**NOPSEMA**

Planned Inspection

Facility: Northern Endeavour  
Operator: Woodside Energy Ltd  
Offshore Inspection Dates: 25 April – 30 April 2014

Report Number 982

Figure 3 – LPG pump A discharge line insulation      Figure 4 – Corroded open drains level gauge

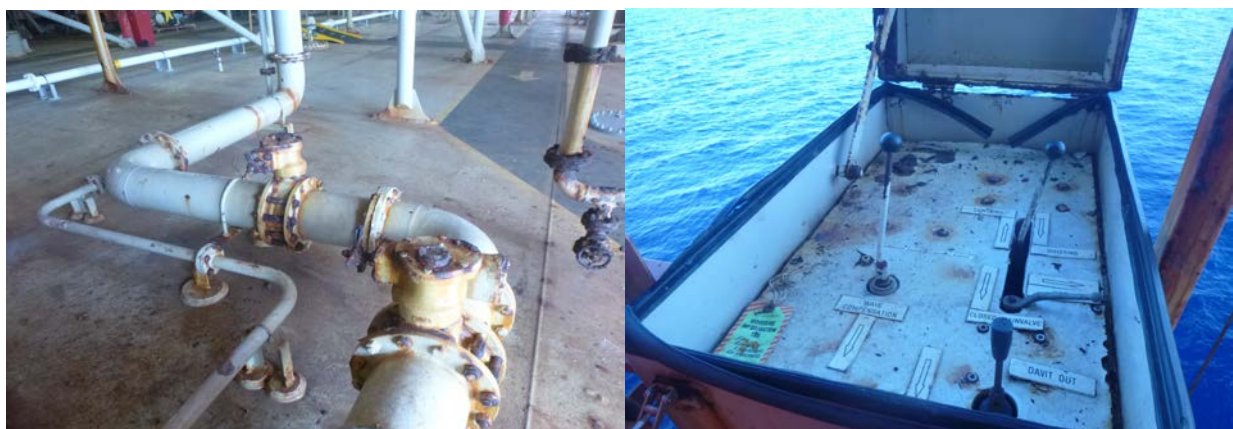
- There are several corrosion related findings:
  - Insulation on the LPG pump A discharge line (35-TE-011) is open to the elements so that the pipe is exposed to water beneath the insulation.
  - Starboard hazardous open drains level gauge 47-LG-006 and surrounding pipework is in very poor condition and requires repair.
  - Port hazardous open drains level gauge 47-LG-003 is in very poor condition and requires repair. A notification was raised (2100071754) on the 10 October 2010 for its repair.
  - Two isolation valves on the water ballast lines to slop tanks have their handles corroded off.
  - The Fast rescue Craft (FRC) launch controls box is in very poor condition

WEL to take action to rectify the following issues related to corrosion:

- Insulation on the LPG pump A discharge line (35-TE-011) is open to the elements so that the pipe is exposed to water beneath the insulation.
- Starboard hazardous open drains level gauge 47-LG-006 and surrounding pipework is in very poor condition and requires repair.
- Port hazardous open drains level gauge 47-LG-003 is in very poor condition and requires repair. A notification was raised (2100071754) on the 10/10/2010 for its repair.
- Two isolation valves on the water ballast lines to slop tanks have their handles corroded off.
- The Fast rescue Craft (FRC) launch controls box is in very poor condition.
